CITY OF VAUGHAN

EXTRACT FROM COUNCIL MEETING MINUTES OF NOVEMBER 29, 2022

6. RUTHERFORD LAND DEVELOPMENT CORP. DRAFT PLAN OF SUBDIVISION FILE 19T-18V001, SITE DEVELOPMENT FILE DA.19.010 - VICINITY OF RUTHERFORD ROAD AND JANE STREET

TITLE: RUTHERFORD LAND DEVELOPMENT CORP.
DRAFT PLAN OF SUBDIVISION FILE 19T-18V001
SITE DEVELOPMENT FILE DA.19.010
VICINITY OF RUTHERFORD ROAD AND JANE STREET

Draft Plan of Subdivision **File 19T-18V001**

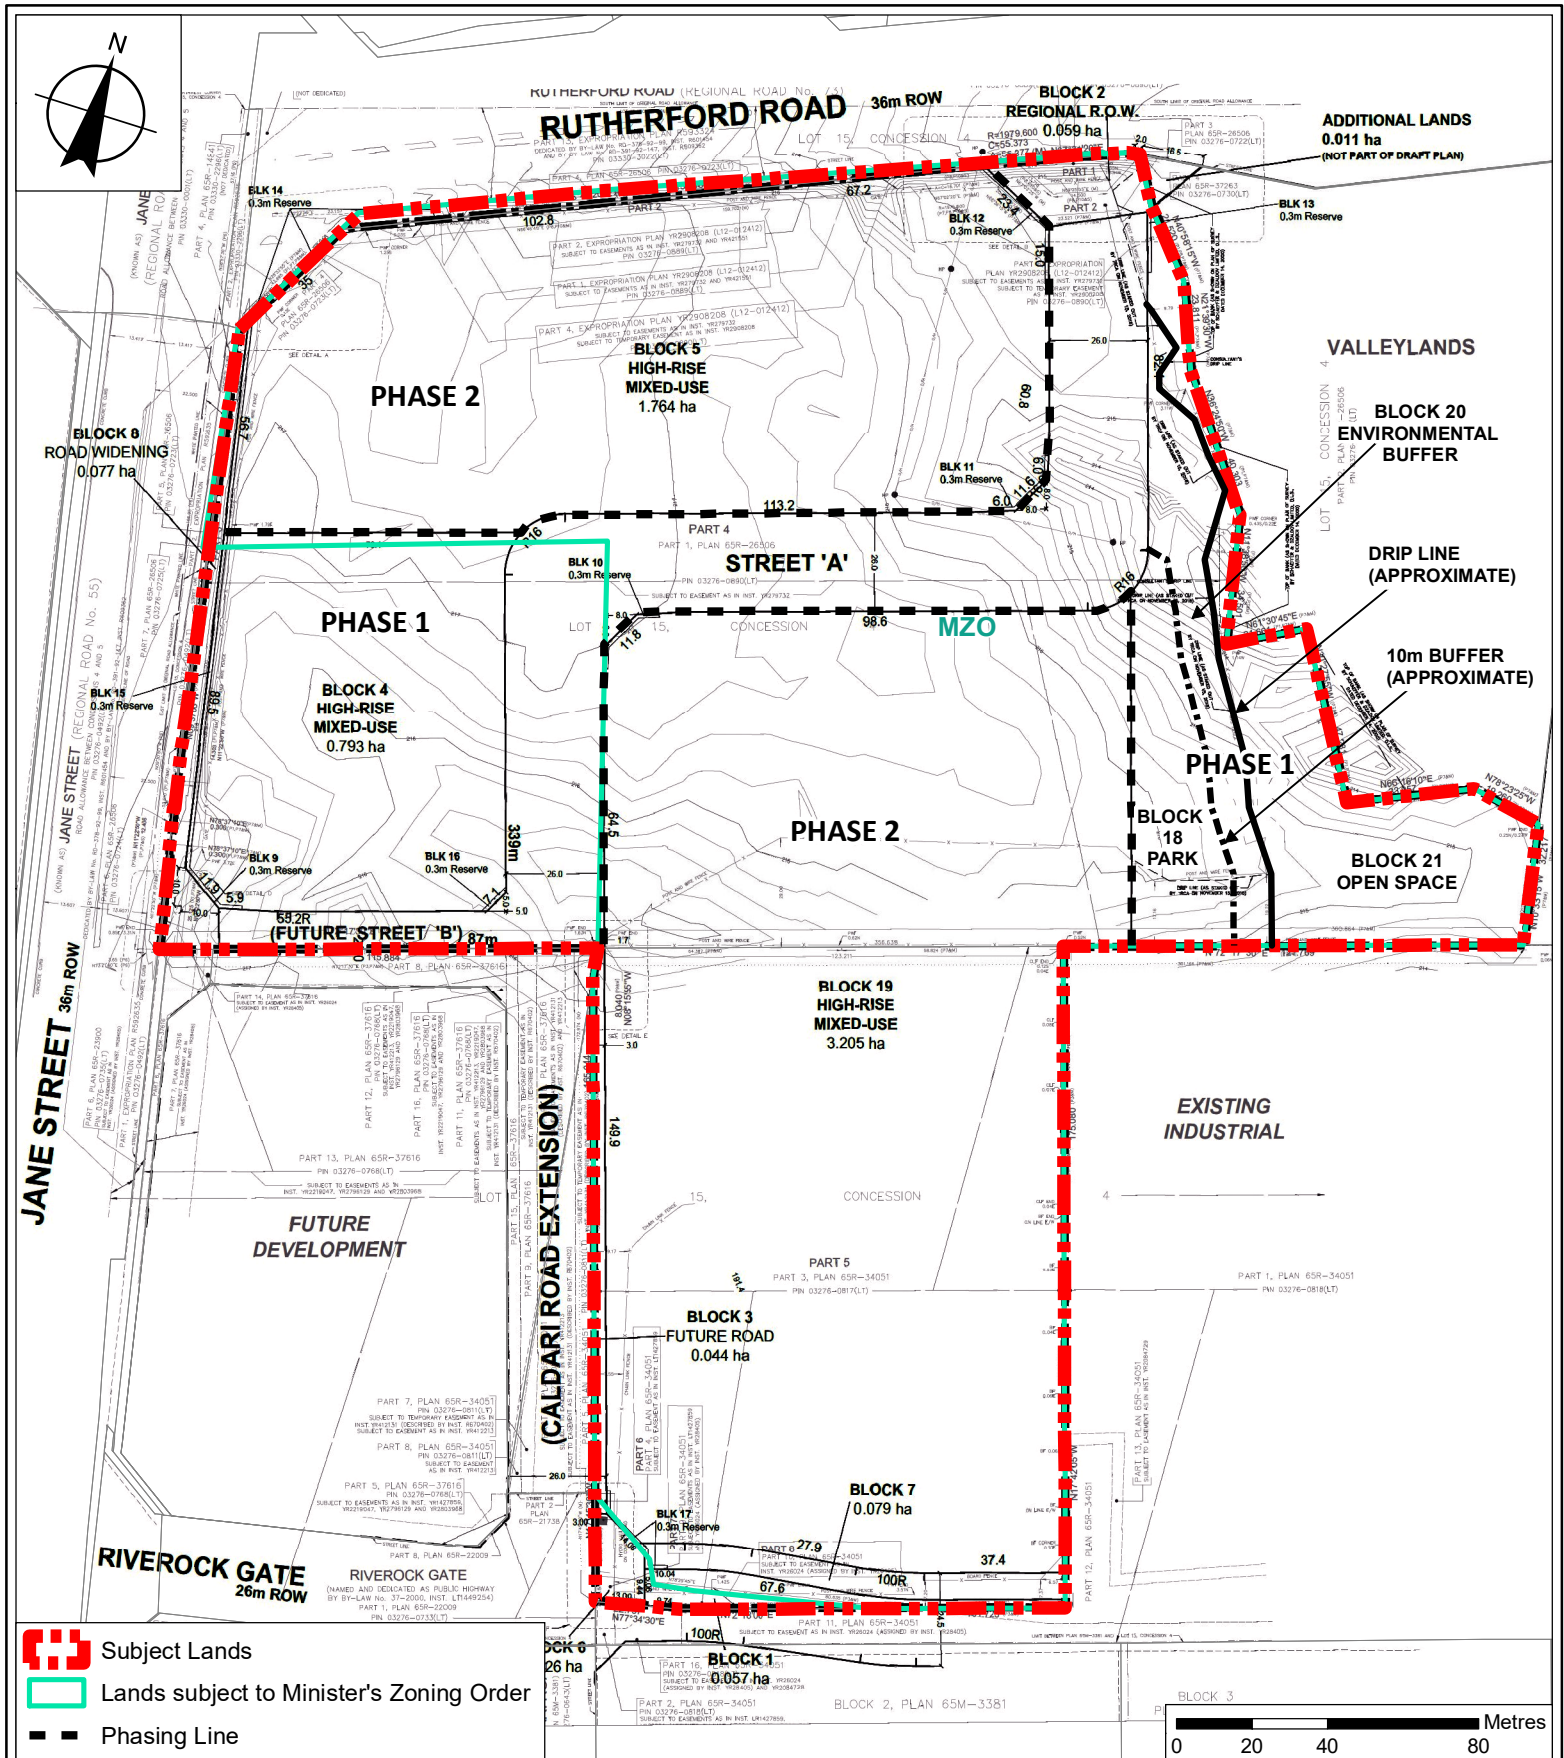
The Draft Plan shown on Attachment 4, consists of three (3) blocks for High-Rise Mixed-Use development, a park block, a buffer block, an open space block, the

The Draft Plan will be phased to facilitate the registration of the Phase 1 lands, as shown on Attachment 4, in advance of the registration of the balance of the blocks in the Draft Plan, which are subject to an MZO. The Owner has not yet fulfilled its obligations as outlined in the Member's Resolution for the MZO adopted by Council. As such, the City is not in a position to move forward with the final approval for the registration of the Draft Plan outside of the Phase 1 lands until it is satisfied that the Owner has fulfilled its obligations as requested by Council. A condition to this effect is included in Attachment 1.

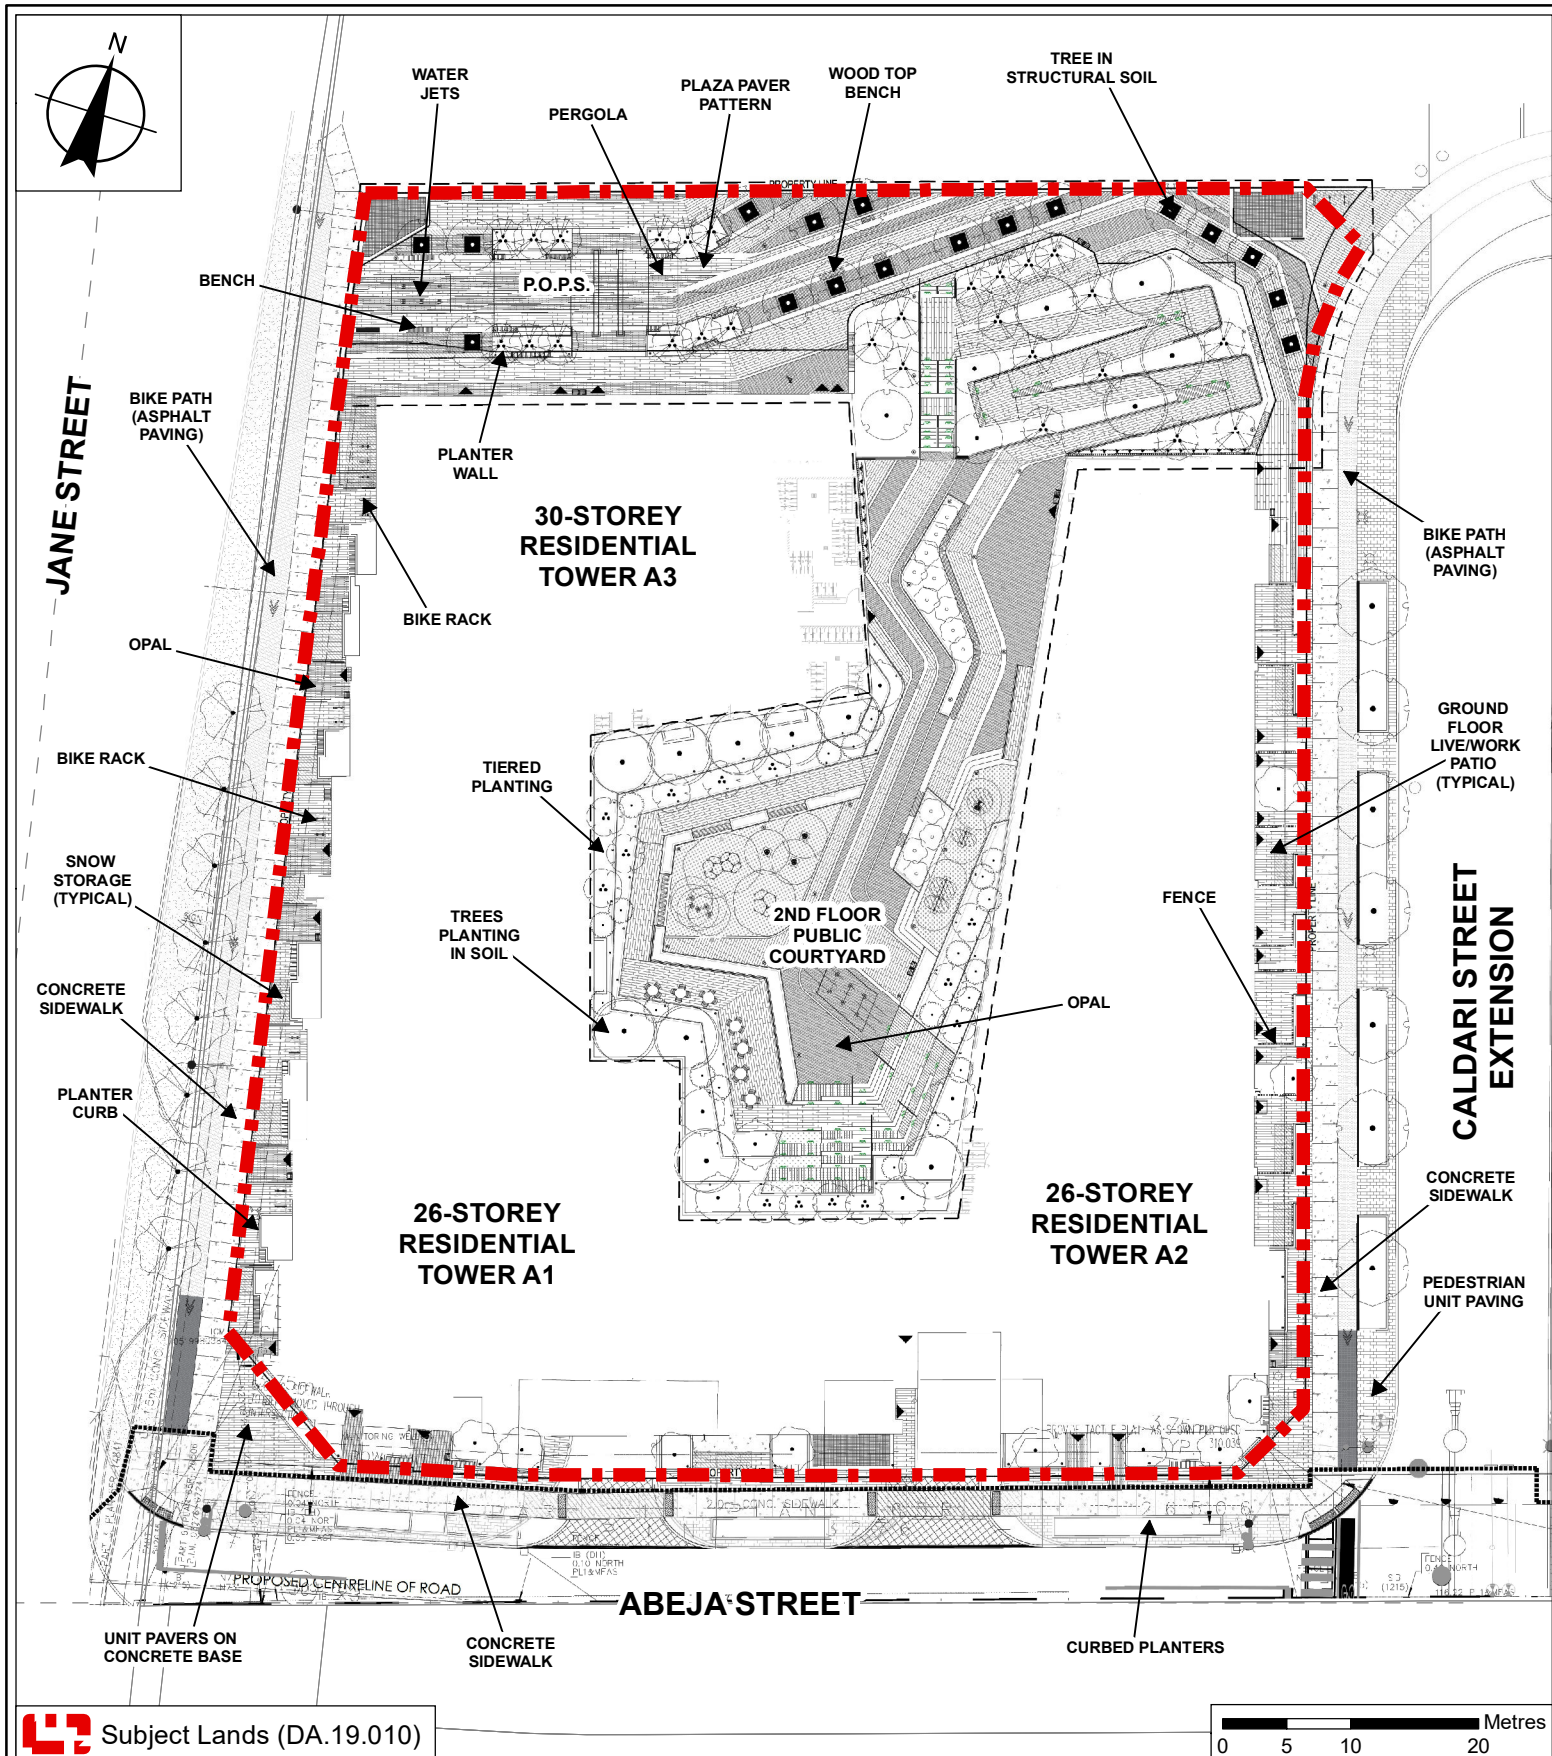
The Landscape Plan is shown on Attachment 6. Urban Design staff satisfied with the landscape plan subject to the Owner making the following changes:

- the sidewalk and the bike lane need to be separated by the planting area, and the boulevard's cross section shall be revised to provide an unencumbered tree planting zone

- the ground sign at the Jane Street frontage shall be realigned to face the sidewalk and preferably move it close to the airshaft to visually screen the airshaft, which is close to the sidewalk, and to remove additional obstruction to the sight lines to the POPS.

- Please provide a key plan, depicting the exact boundaries of the POPS, the City's right-of-way, the regional right-of-way and a corresponding landscape cost estimate.
